The Public Works Department has had the opportunity to review the BLD Group Sketch Plan and has the following comments:

**RE: New Castle Townhomes – Sketch Plan
BLD Group**

Paul Smith
Town of New Castle
Ref: BLD Group Sketch Plans

RESIDENTIAL STREET
 58'-0" ROW SECTION
 TOWN OF NEW CASTLE
 NOT TO SCALE
 DWG: ST-10

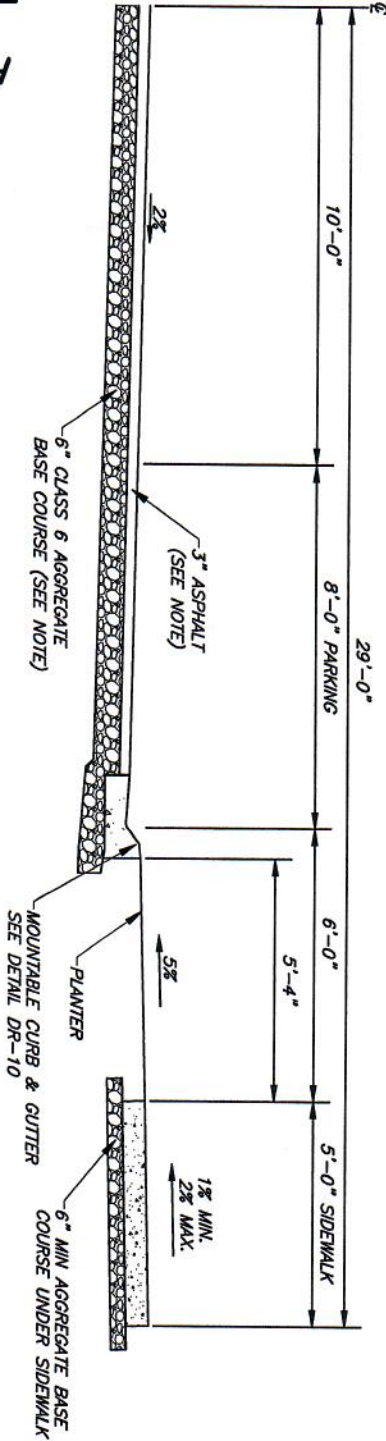
The main development roadway should have a minimum right-of-way of fifty eight feet (58), with a paved portion of thirty-six feet (36'), measured flow line to flow line. Pinch points for traffic calming and pedestrian crossing will be considered. Sidewalks are required on both sides of all streets and shall be at least five feet (5') wide and detached from the roadway. Residential streets shall generally have a "mountable" curb. See attached Residential Streets Cross Section.
